■ Replacing ROM

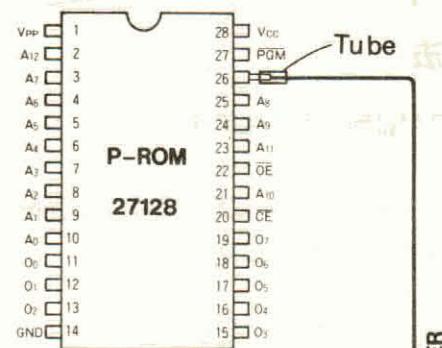
1. Remove the Panel and the keyboard from the JX-3P's body.
2. Take out the ROM IC 52 (2764 or 23665) from the IC Socket on the Main Board.
3. Straighten the pin 26 of the new ROM (27128) and push it in the IC Socket.
4. Connect the Pin 26 (A13) of the CPU IC 44 (8031 or 8051) to the Pin 26 (A13) of the ROM IC 52 (27128) by using a jumper wire.
5. Turn the JX-3P on and make sure it works properly. Then replace the Panel and the keyboard onto the body.
